P.O.A.D.P.

INFORMATION SHEET FOR
PRELIMINARY OVERALL AREA DEVELOPMENT PLAN
(P.O.A.D.P.)

SITTERLE STONE OAK TRACT

Date: August 7, 1984

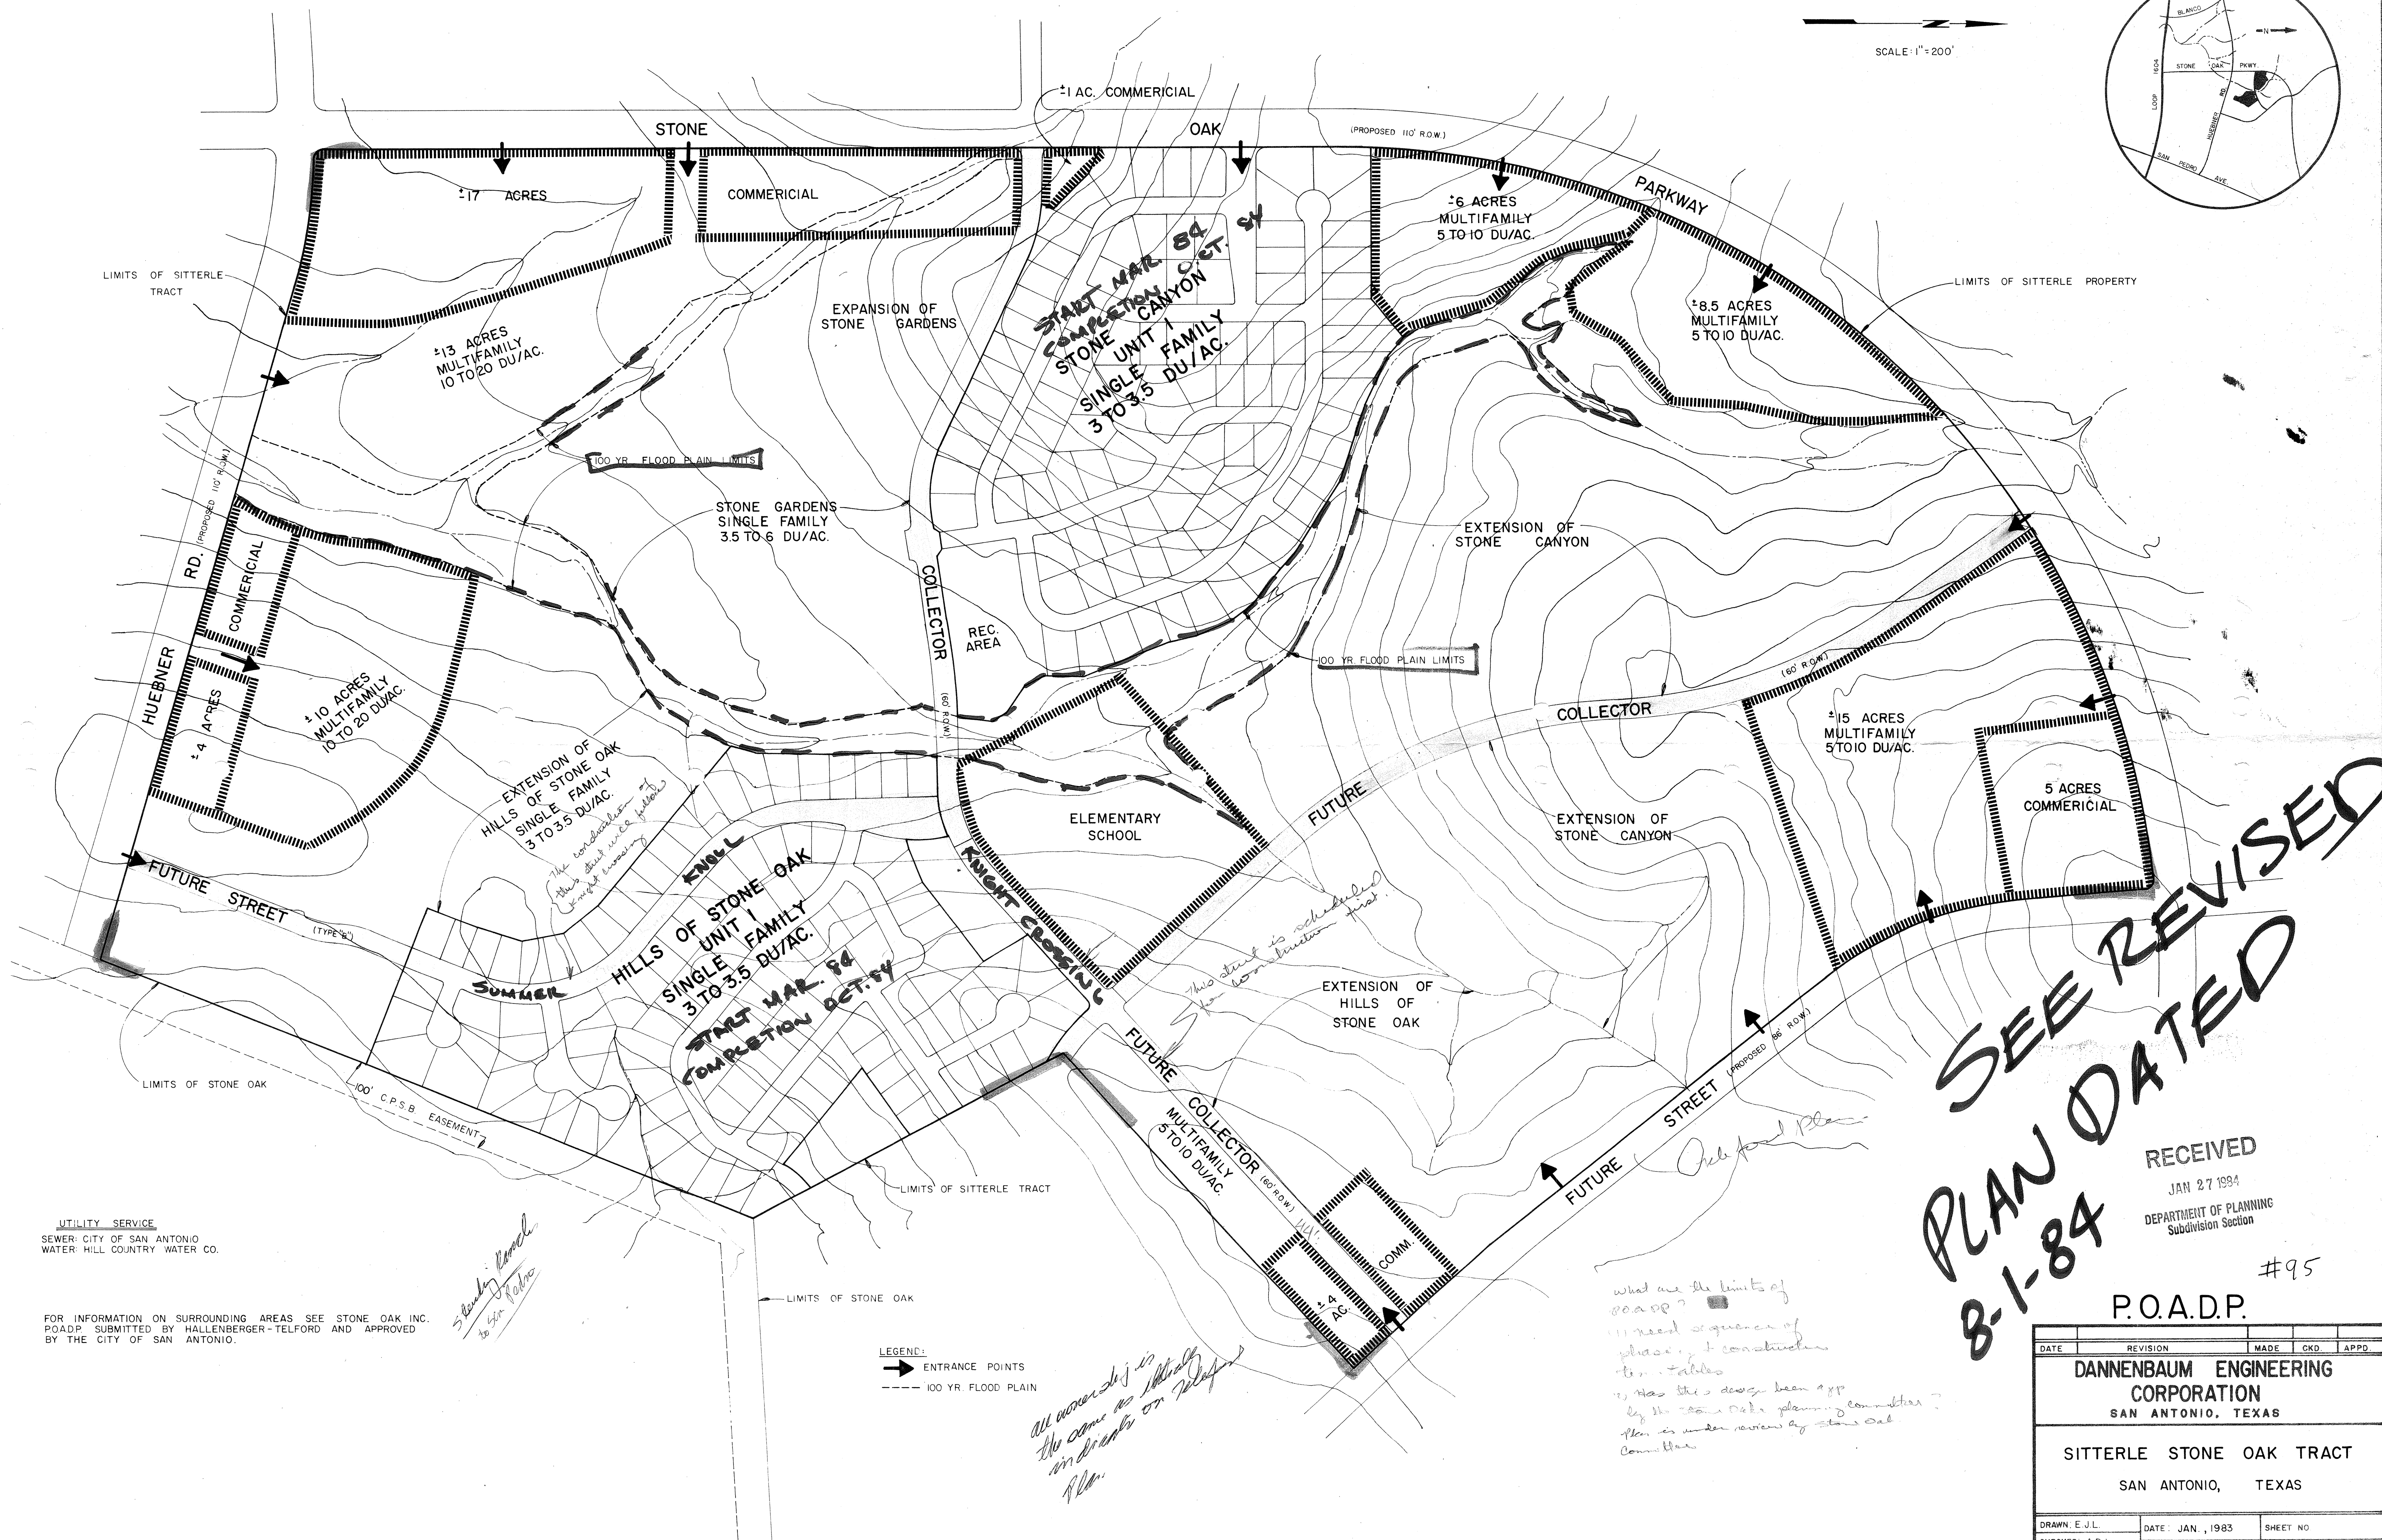
☒ Comments: This acknowledges receipt of the revised plan reflecting the design layout for the area identified as Hills of Stone Oak Unit-2. Staff has no objections to the proposed layout.
